APPLICATION FOR PERMIT TO DRILL OR REENTER

2. Name of Operator EOG RESOURCES INCORPORATED		8. Lease Name and Well No. DEEP ELEM 4 FED COM
3a. Address 1111 BAGBY SKY LOBBY 2, HOUSTON, TX 77002		9. API Well No. 30-015-54086
3b. Phone No. (include area code) (713) 651-7000		10. Field and Pool, or Exploratory PURPLE SAGE;WOLFCAMP (GAS)

EOG RESOURCES, INC.
DEEP ELEM 4 FED COM #803H

PECOS DISTRICT DRILLING CONDITIONS OF APPROVAL

Proposed Wellbore
Design B

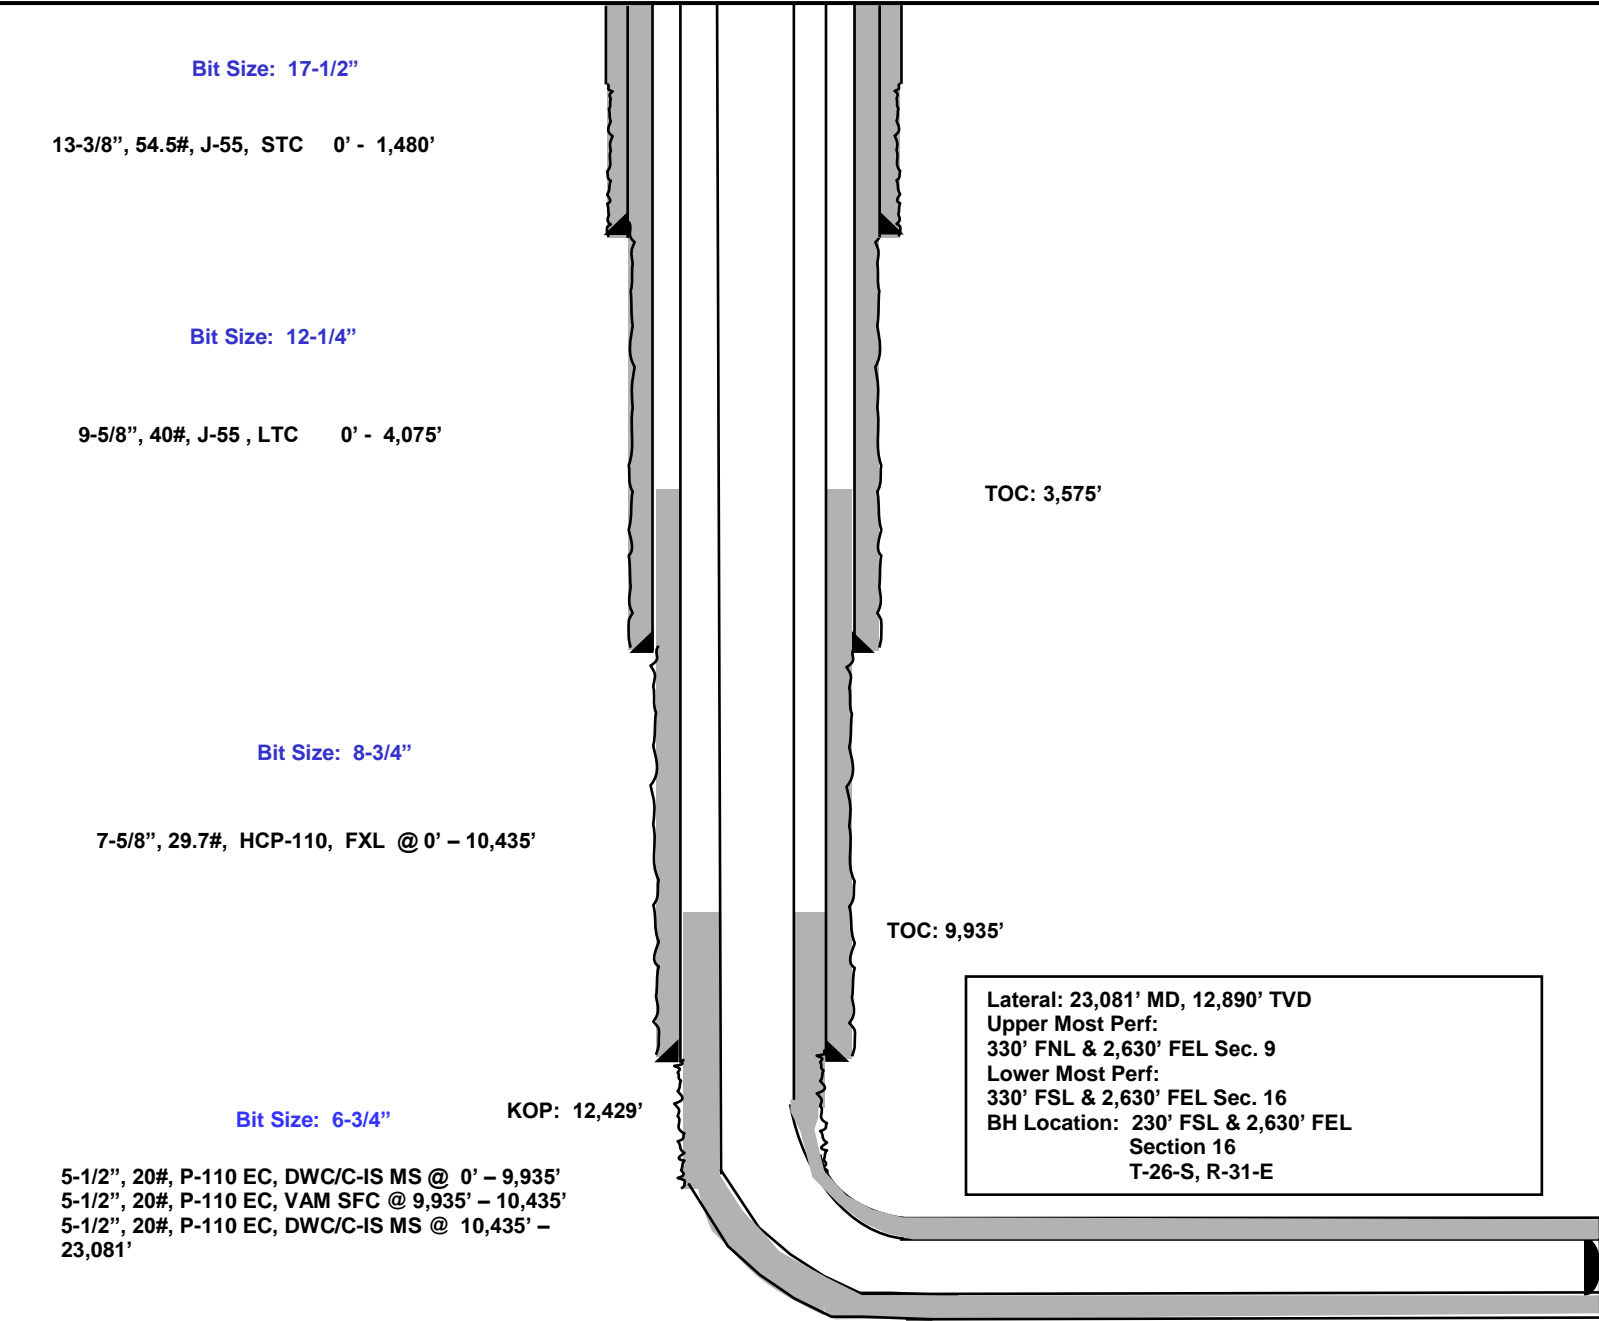
Operator is only approved for Design A. Design B is not to be utilized. If Design B is needed or any other change, please submit a NOI sundry to make the changes.
